MIL-P-48698 (AR)
AMENDMENT 5
13 September 1996
SUPERSEDING
AMENDMENT 4
11 May 1992

MILITARY SPECIFICATION

PROBE AND S&A ASSEMBLY, TOW-2/E6

Figure 7. Acceptance criteria for leaf spring contact (front view)

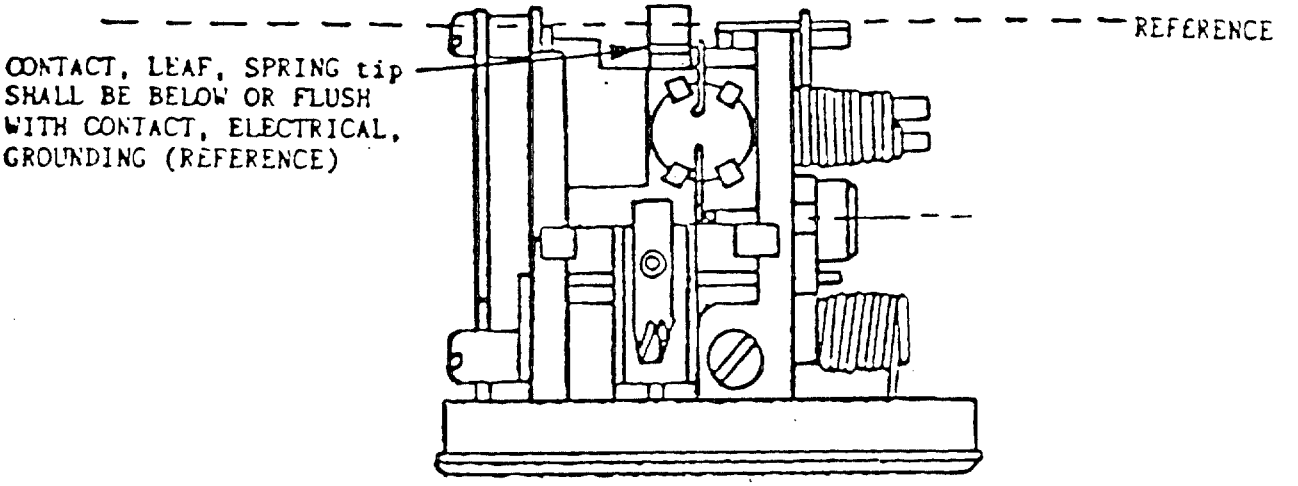
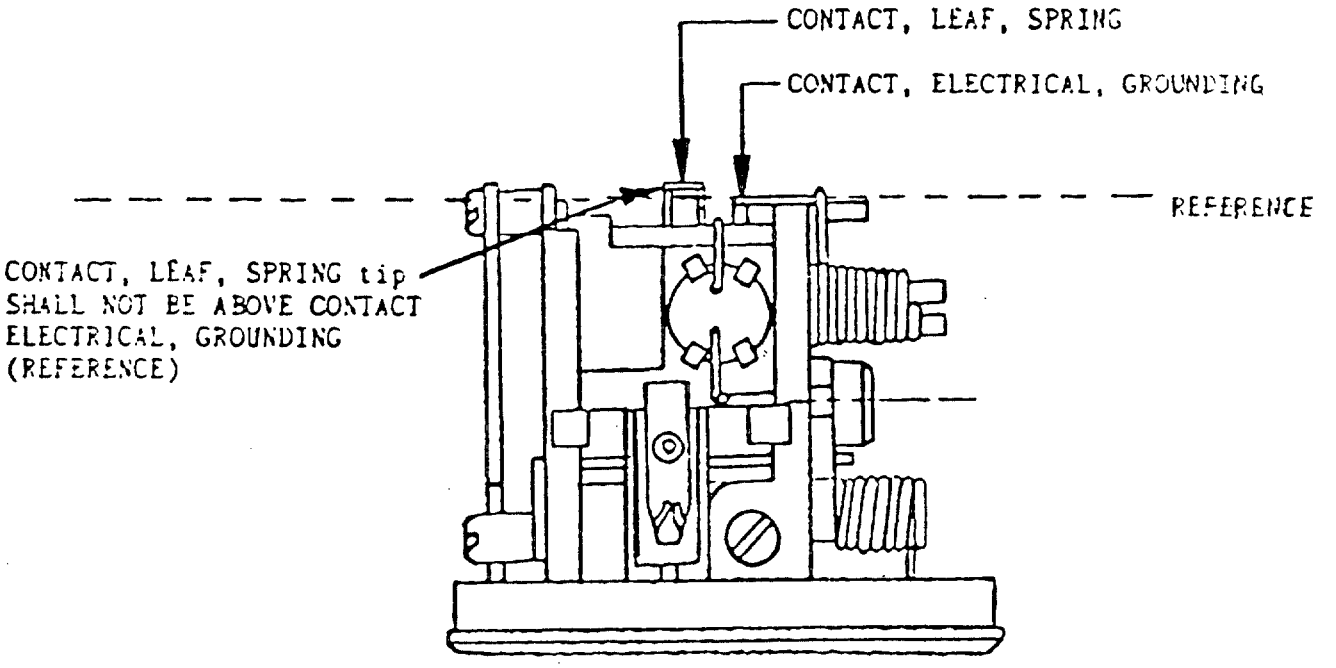
"4.5.17, Visual examination for proper leaf spring contact position (See Figure 7 and 8). This examination shall be performed 100 percent at the receiving inspection of the M114 S&A devices."

Add Figure 7, included.

Figure 8. Acceptance criteria for the leaf spring position (side views).

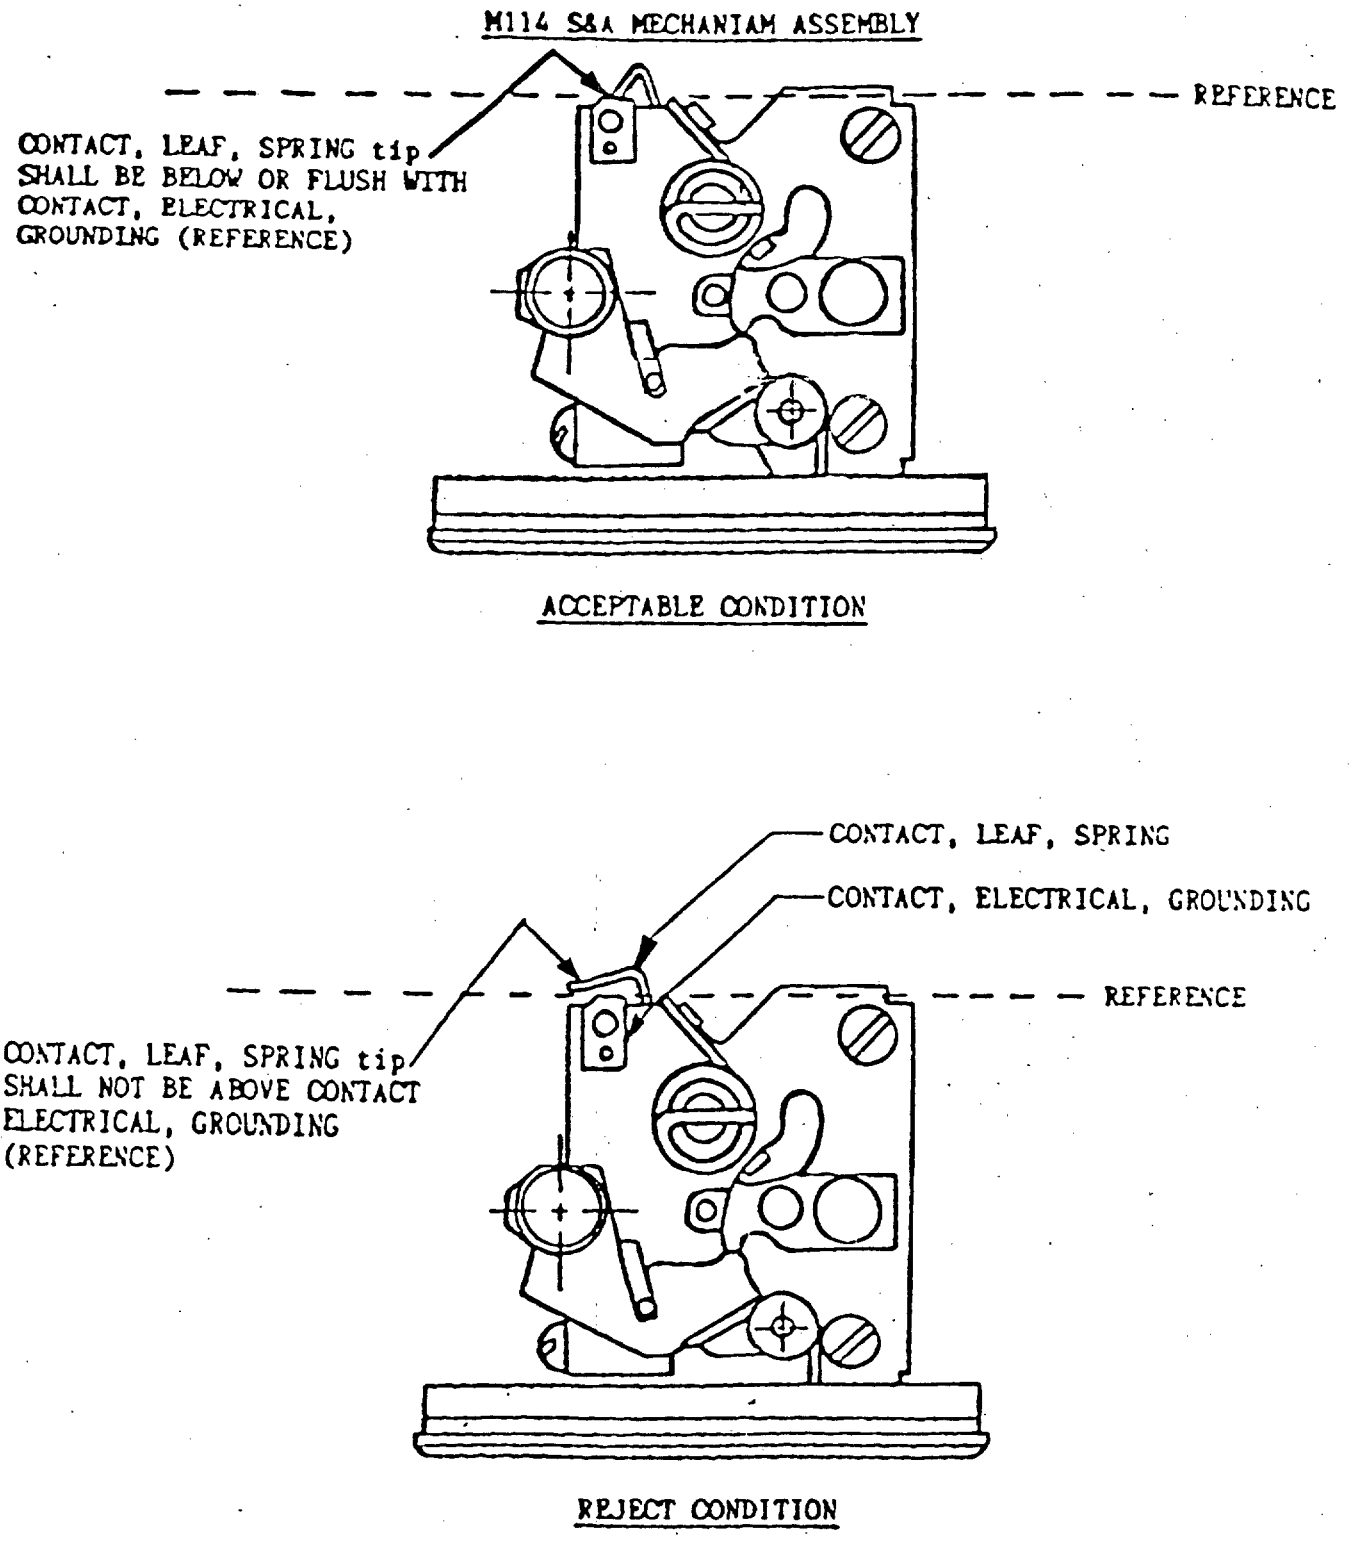
Add Figure 8, included.

Figure 9. The safe condition of the M114 Safety and Arming Device

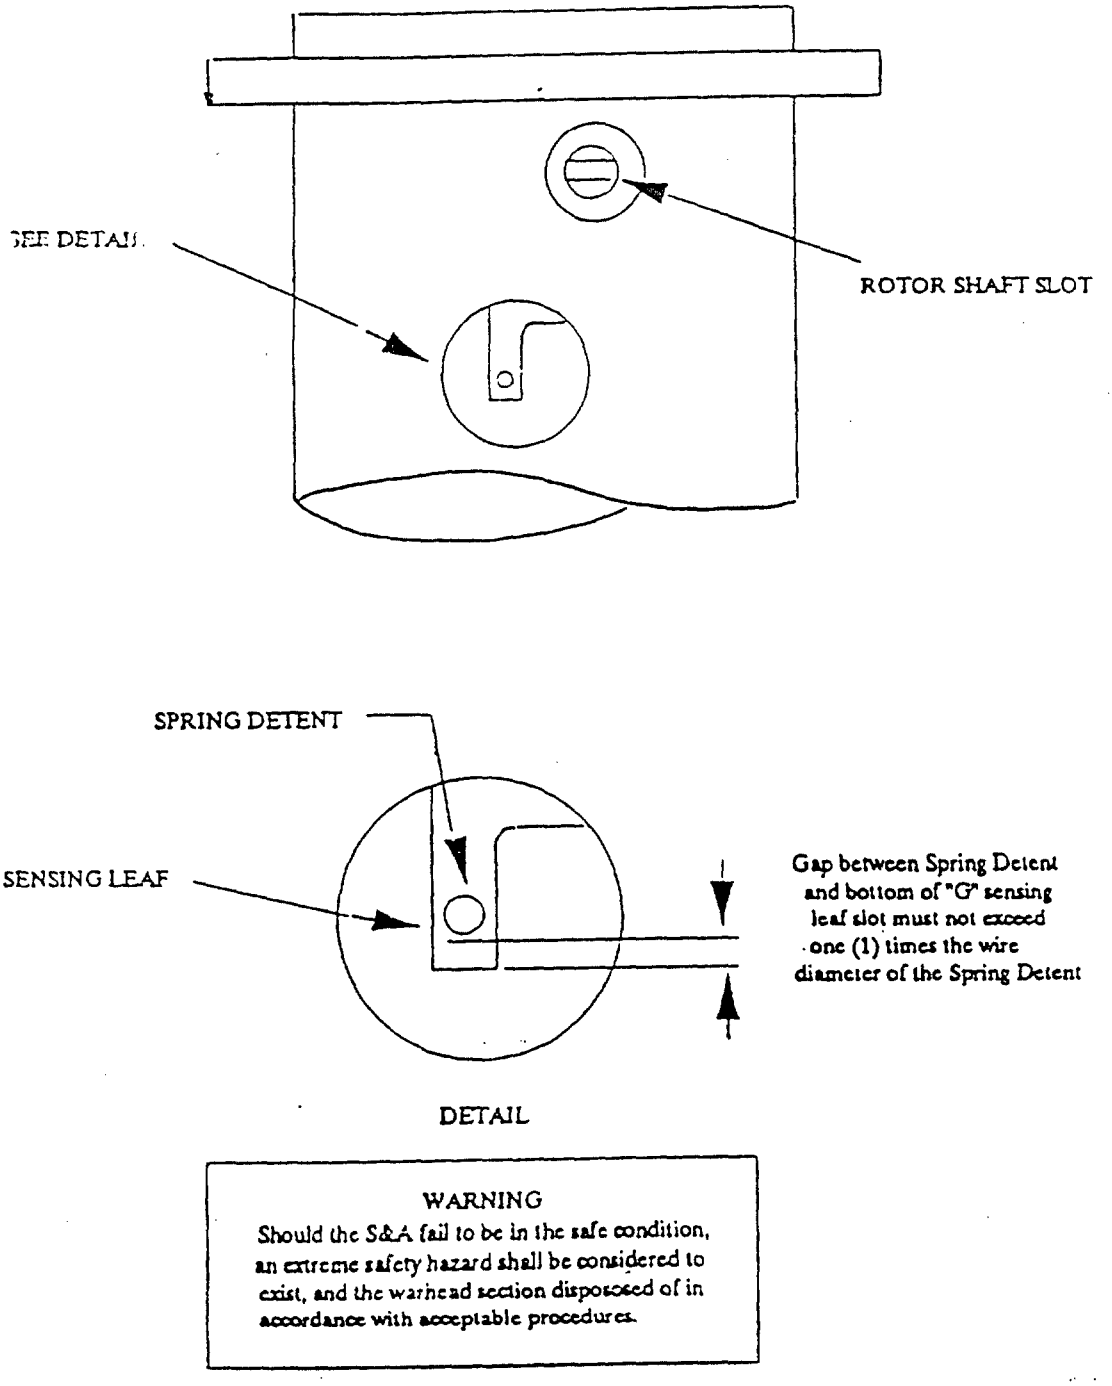
CLASSIFICATION	EXAMINATION OR TEST	CONFORMANCE CRITERIA	REQUIREMENT PARAGRAPH	INSPECTION METHOD REFERENCE
Critical	(See Note 1)			
1	Position of rotor shaft not horizontal	100%	3.4	Visual/(See Fig. 9)
2	Improper gap between spring detent and "G" sensing leaf (Greater than or equal to two wire diameters)	100%	3.4	Visual/(See Fig. 9)
Major				
101	Absence of piston actuator	100%	3.4	Visual
102	Absence of safety screw	100%	3.4	Visual
103	Improper gap between spring detent and "G" sensing leaf (one or two wire diameters)	100%	3.4	Visual/(See Fig. 9)

Add Figure 9, included.

Figure 10. Safety of the detent spring position

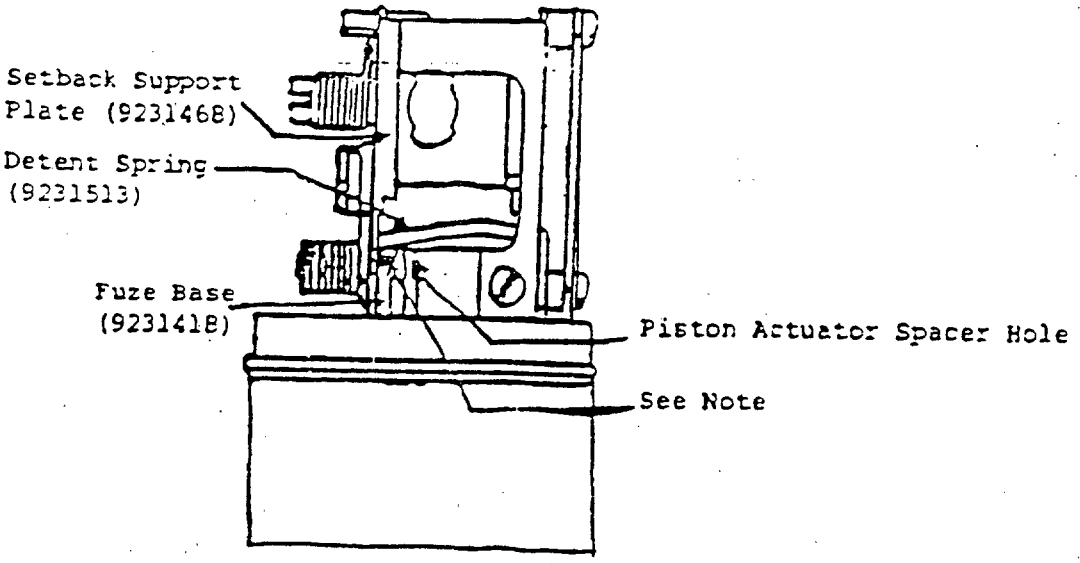
a. Prior to the assembly of the modified M114 S&A into the probe, visually inspect the safety of the detent spring position as shown in Figure 10.

Add Figure 10, included.

"Note Detent spring (9231513) shall contact the fuze base (9231418) between the piston actuator spacer hole and the setback support plate (9231468), as shown.

Figure 11. Acceptance criteria for Rotor Spring Assembly

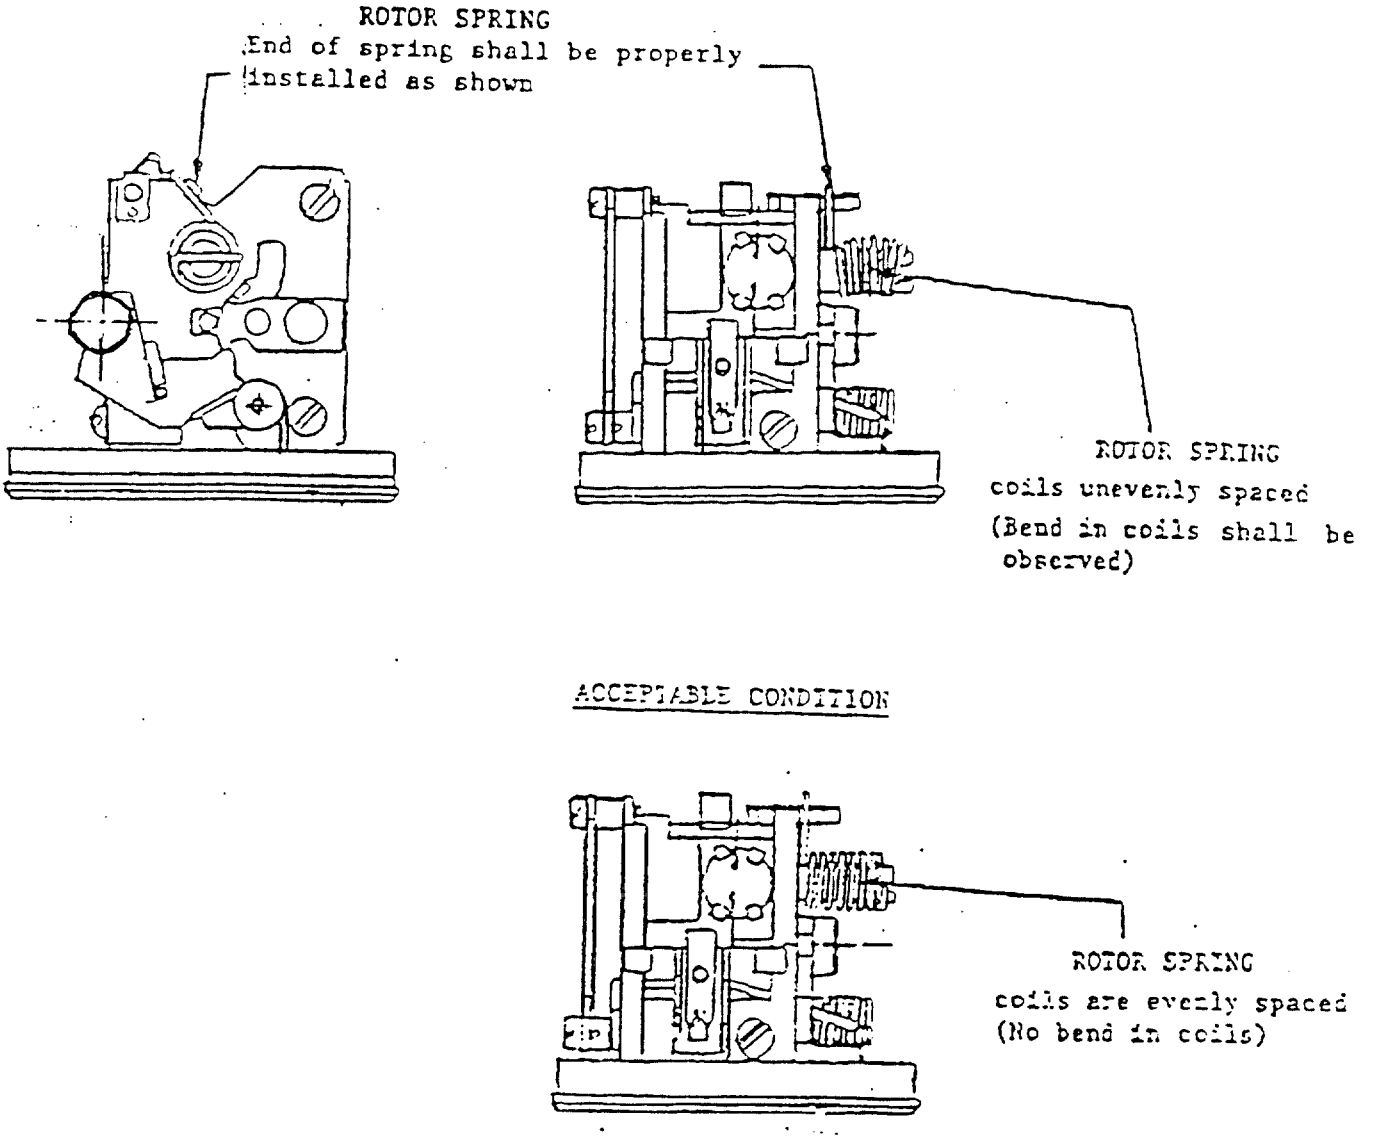
"4.5.18, Visual inspection for proper installation of rotor torsion spring (See Figure 11). This inspection shall be performed 100 percent following removal of the S&A cover before assembling device into probe. A unit found to be improperly assembled shall be set aside. Authorized Government personnel shall perform an analysis as to cause."

Add Figure 11, included.
